## HISTORIC AND DESIGN REVIEW COMMISSION

April 07, 2021

**HDRC CASE NO:** 2021-159  
**ADDRESS:** 934 DAWSON ST  
**LEGAL DESCRIPTION:** NCB 1370 BLK 2 LOT 17  
**ZONING:** RM-4, H  
**CITY COUNCIL DIST.:** 2  
**DISTRICT:** Dignowity Hill Historic District  
**APPLICANT:** JESSICA WALKER/JD Walker Designs  
**OWNER:** Bruce Robison/SATX DESIGNS  
**TYPE OF WORK:** Addition  
**APPLICATION RECEIVED:** February 19, 2021  
**60-DAY REVIEW:** Not applicable due to City Council Emergency Orders  
**CASE MANAGER:** Huy Pham  
**REQUEST:**

1. Construct a rear 2-story addition.
2. Replace the front facing door with a new window and modify or remove up to 9 window openings.
3. Replace the metal roof with composition shingles.

② REAR ELEVATION

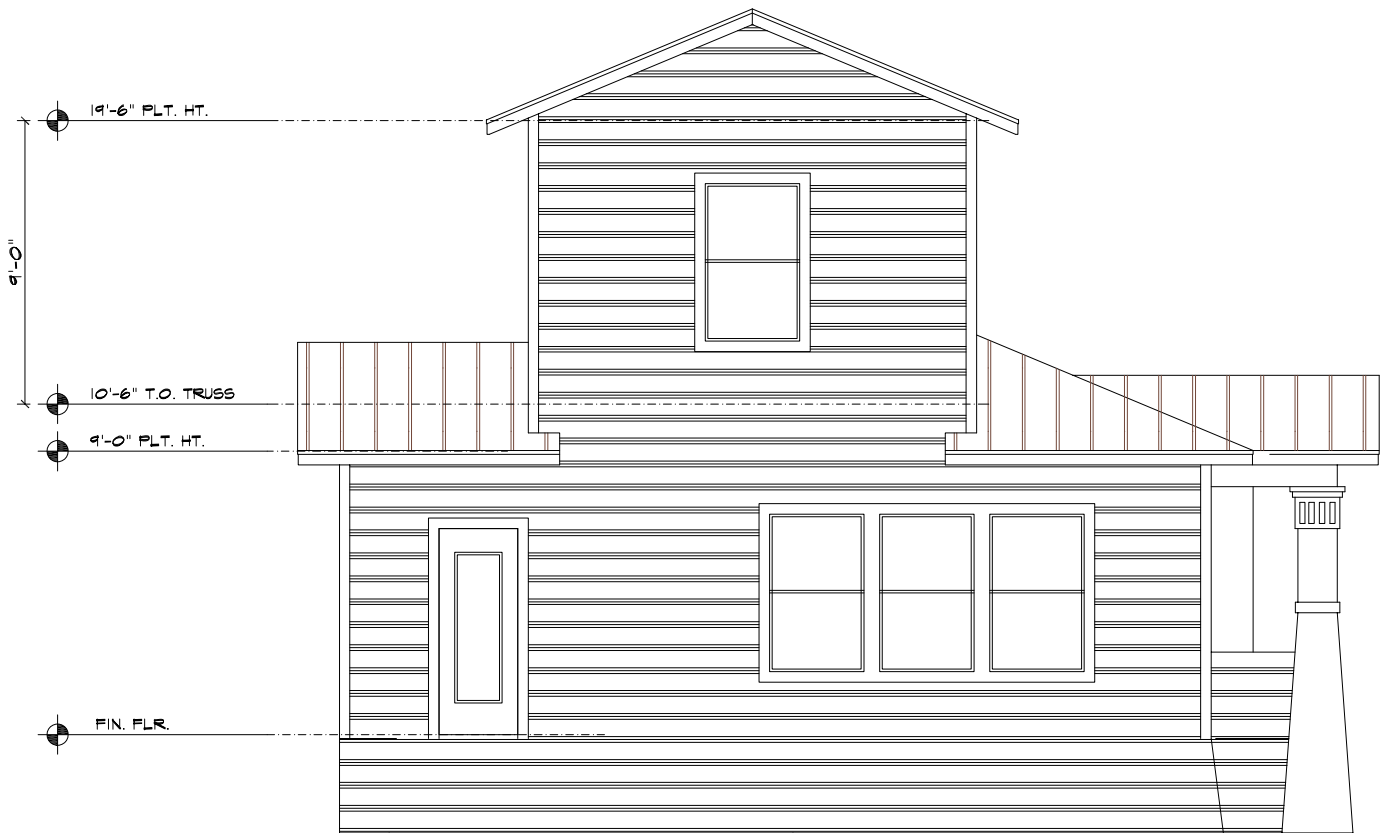
- b. ADDITION – The applicant has proposed to construct a rear addition featuring approximately 30 feet in width and 13 feet in depth with a centered two-story room with matching siding and roofing.

- e. ADDITION TRANSITION – Per the Guidelines for Additions 1.A.iv., applicants should utilize a setback or recessed area and a small change in detailing at the seam of the historic structure and new addition to provide a clear visual distinction between old and new building forms. Staff finds that a visual transition should be incorporated into the design such as a vertical trim piece between new and old forms.

- i. That a visual transition should be incorporated into the design such as a vertical trim piece between new and old forms.
- ii. The final window product should adhere to the *Standard Specifications for Windows in New Construction* and submitted to staff prior to purchase and installation.

① FRONT ELEVATION

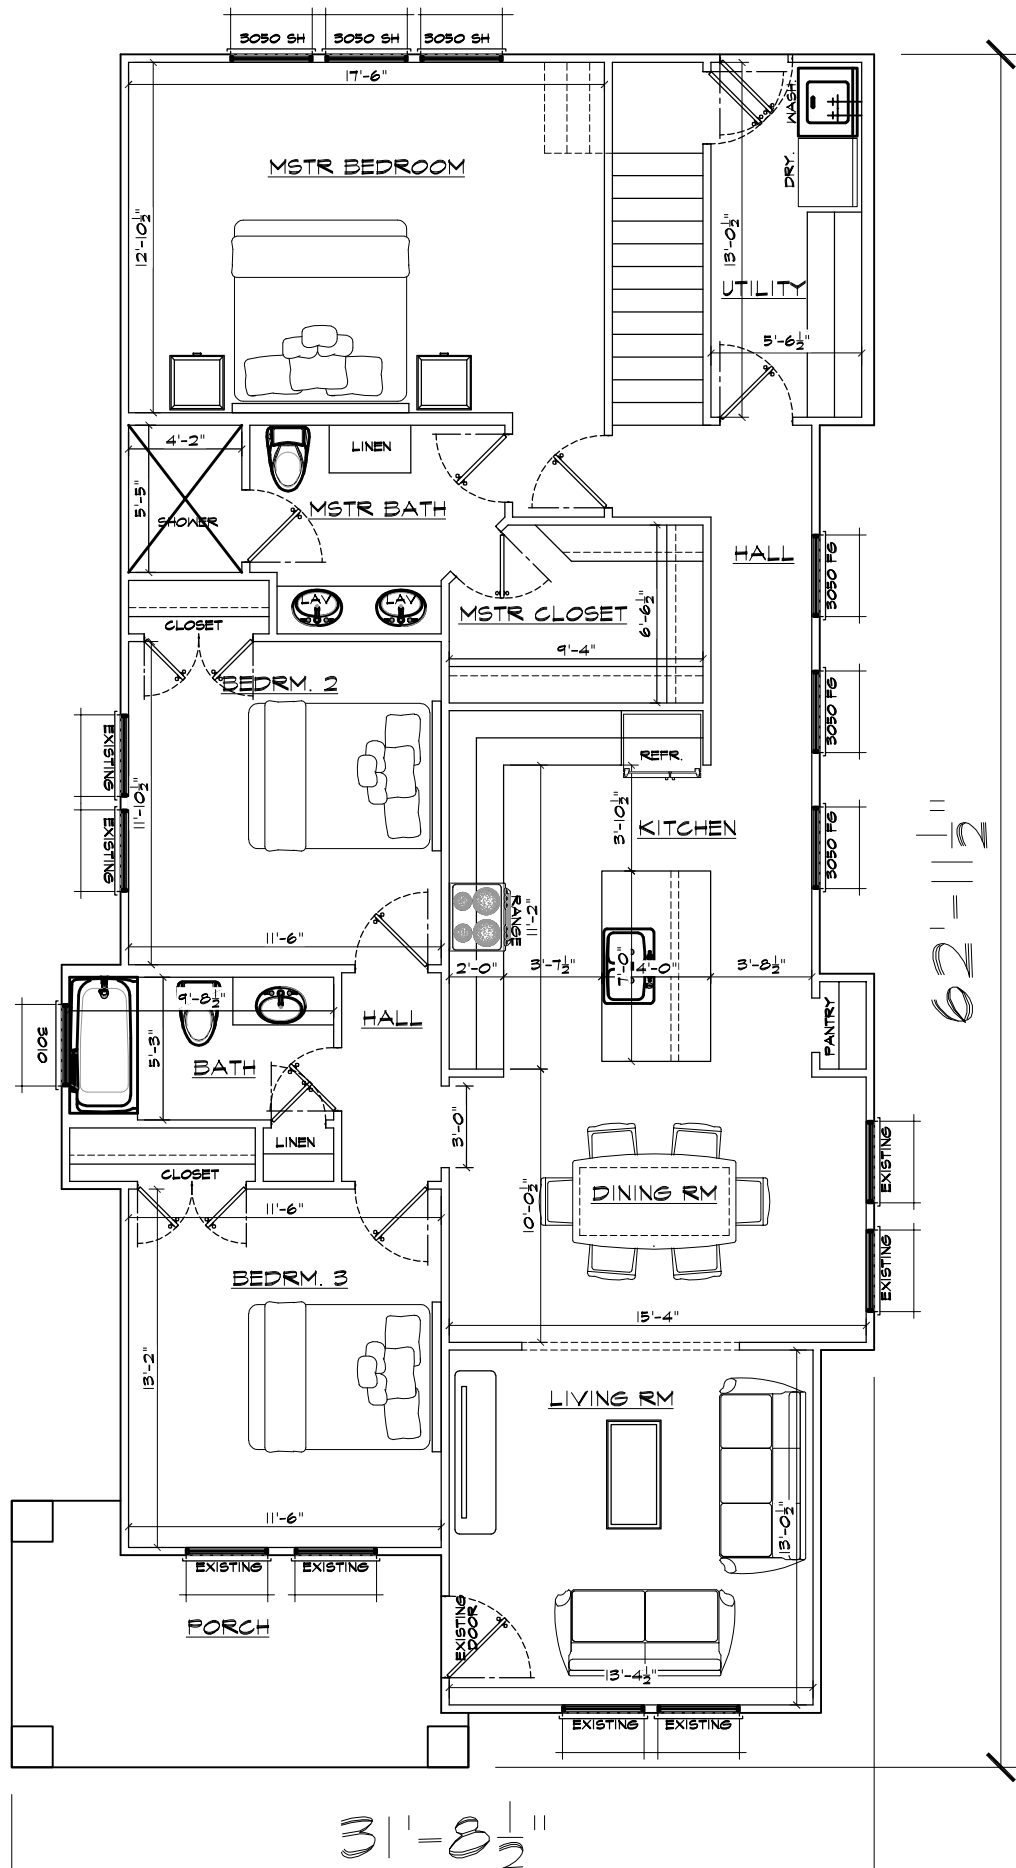
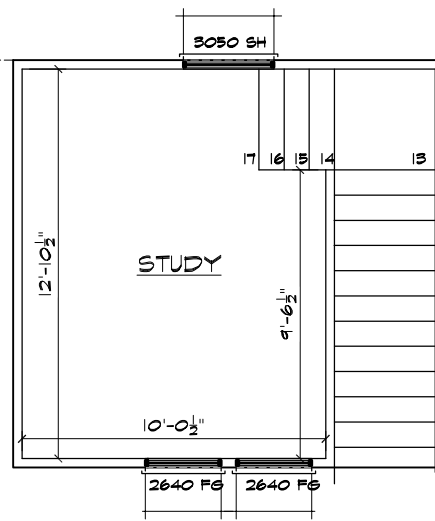
- k. EXISTING DOOR & WINDOWS – Per the submitted drawings, the applicant has proposed to replace the front facing door with a new window and modify or remove up to 9 window openings. Per the Guidelines for Exterior Maintenance and Alterations 6.A.i., applicants should preserve existing window and door openings and avoid filling in historic door or window openings. Staff finds that the front facing door and all existing window openings on the historic structure is preserved with the allowance to modify the rear façade if the addition is approved. To accommodate interior floorplans, the applicant may install furr walls without removing, modifying, or infilling existing exterior openings.

Staff does not recommend approval of item 2. Door replacement and window modification based on finding j. To accommodate interior floorplans, the applicant may install furr walls without removing, modifying, or infilling existing exterior openings.
